# PARTS & SERVICE NEWS

REF NO. AA02107

**SUBJECT:** AIR CONDITIONING COMPRESSOR BELT GUARDS

**PURPOSE:** Introduce to the field a newly improved compressor belt guard.

FIGURE 1. NEW BELT GUARD (EJ9607)

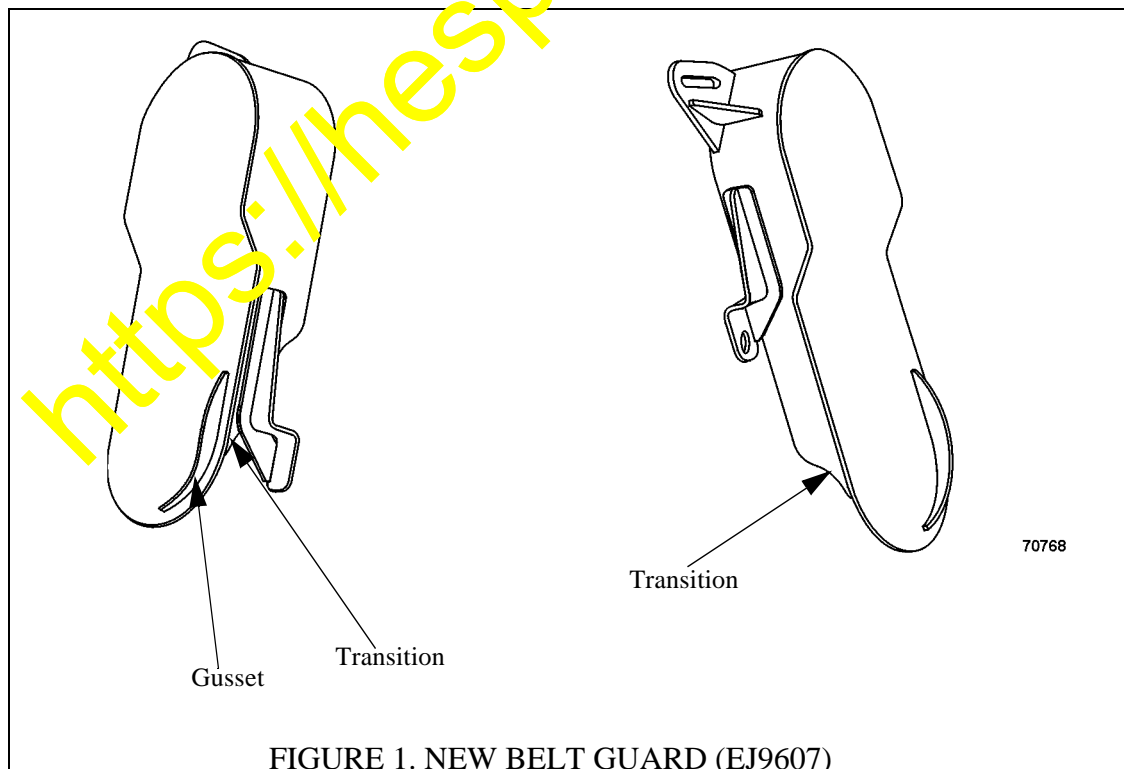
Some trucks in the field may experience cracking at the air conditioning compressor belt guard. A new improved belt guard (EJ9607) has been developed to replace previous belt guard (EH8750), and to prevent this problem from occurring.

Differences in the new belt guard include transitions in the center wrap sheet and an added gusset. Refer to Figure 1.

Truck units A30068 and above will be assembled with the new belt guard.
